Docket # 84-040
Case # ACT/015/025

Co-op Mining Co.

UMC 784.23 Operation Plan: Maps and Plans

FIGURE
NO. 1

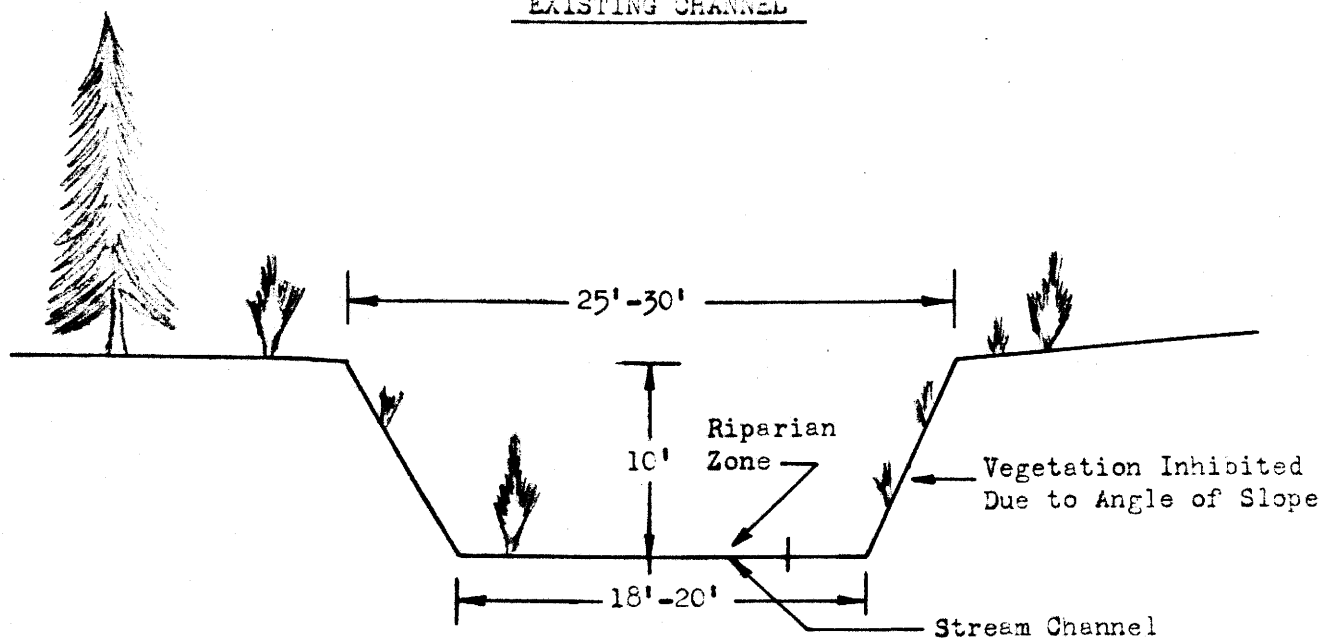
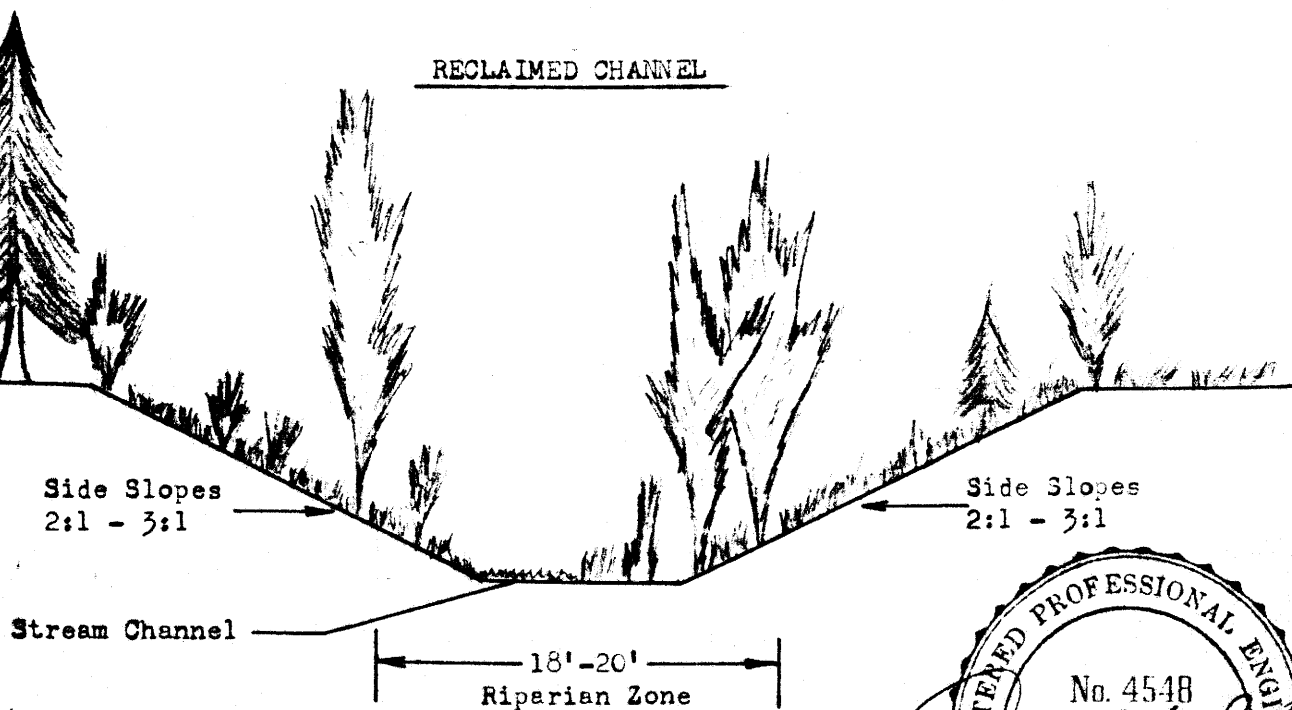
The applicant has not completely addressed this requirement. The applicant has not provided maps, plans and cross-sections to depict postmining drainage patterns. Clarification of a statement in the MRP regarding "horizontal drainage patterns," a postmining drainage map, cross-sections depicting postmining topography and drainage, specific measures for stabilizing reclaimed drainage channels and details on measures proposed for reclamation of the main stream channel where it is currently culverted were not submitted as required. The previous MRP had proposed a log check dam configuration for reclaiming the Bear Canyon stream channel. This proposal was removed by the April 30, 1984 response and the only inference to reclaiming the stream channel is the depiction of eight-inch riprap shown on Plate 3-2.

1. To use a large track mounted excavator in conjunction with a small backhoe and crawler tractor to remove the 60' culvert and to regrade the opposing banks on approximately a 3 to 1 slope to facilitate revegetation and to enhance the establishment of a riparian zone. (Note fig. 1 for the present stream configuration and projected after reclamation).

FIGURE
NO. 2

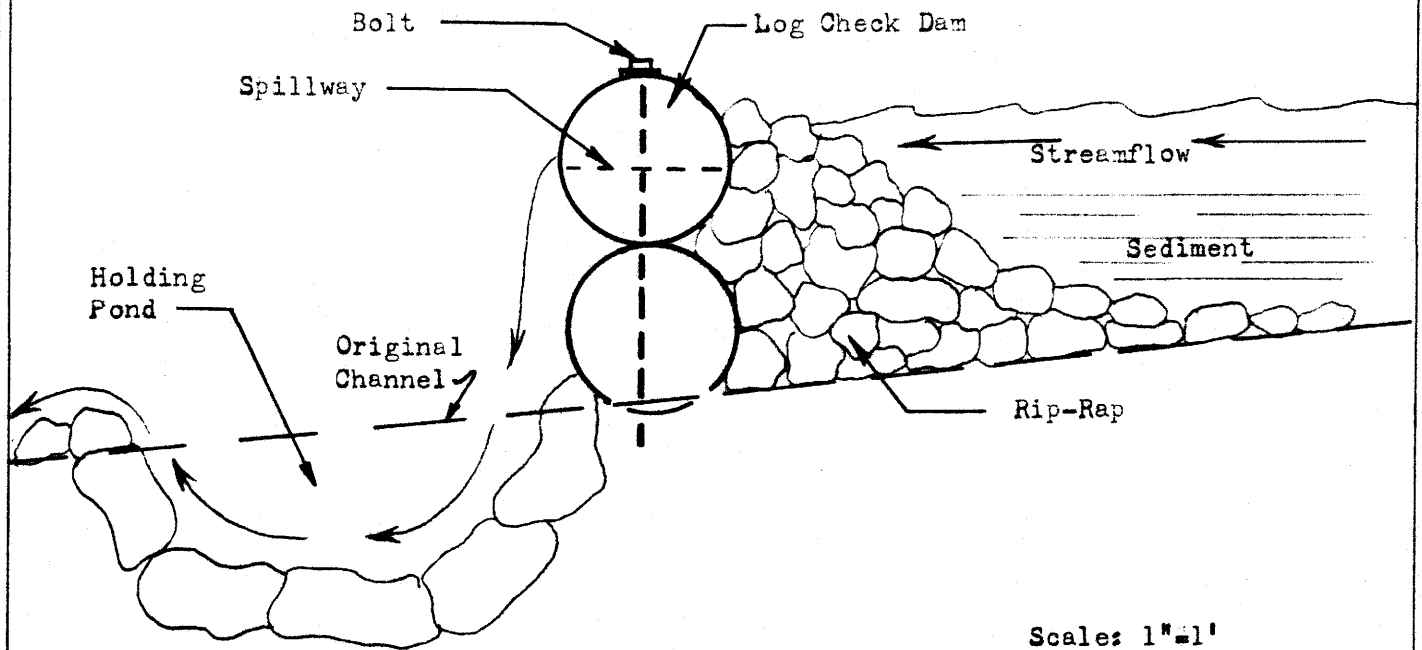
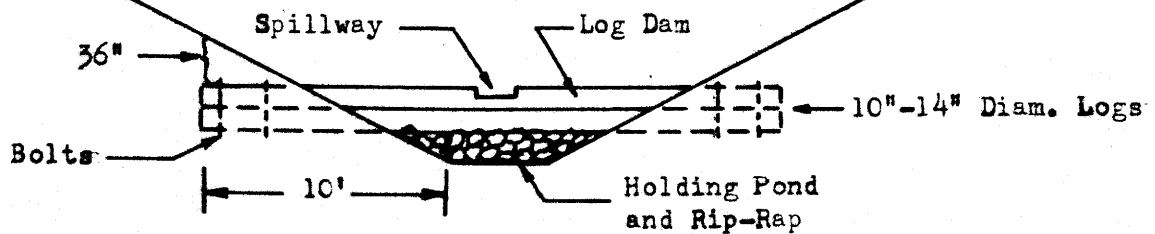
UMC 817.44 Hydrologic Balance: Stream Channel Diversions

2. To construct small holding ponds along the channel utilizing native materials. The actual methodology is to incorporate 2 logs approximately 10 to 14" in diameter, trench into the bank back approximately 10' on both sides of the creek channel, secure the logs together in a stacked manner with 3/4" anchor bolts, buried for approximately 10 feet with approximately 36" of fill material decreasing to 0" as the stream channel is approached. An 18" wide by 5" deep notch cut along the top of the upper log in the center of the creek channel, to create a centralized spill-way. Once the logs are secured into the channel, rock rip-rap should be laid on the up stream side to a height equal to the height of the log retainer and continued up stream for a distance of 36" decreasing in height so as to be level with the original rip-rapped channel. Then by utilizing a backhoe, a pit approximately 3' in diameter should be dug at the fall line of the spillway and lined with large rock 2' +. The log-pond configuration should be repeated at approximately 50' intervals along the course of the creek channel to create a stepped configuration along the area of disturbance.

The intent of the holding ponds created by the log-rock dam is to fill with sediment and minimize the down stream migration

of this potentially detrimental source of silt and convert it into a potentially beneficial, enriched, growth media to facilitate the enlargement and establishment of riparian vegetation. Over a course of time the water holding capability of the ponded area will decrease as the ponds fill with sediment, however, the small ponds at the base of the spillway should remain relatively free from sediment and due to the small surface areas and depth, they will hold water over an extended period during dry seasons. A diagram is attached for your review. (See fig. 2).
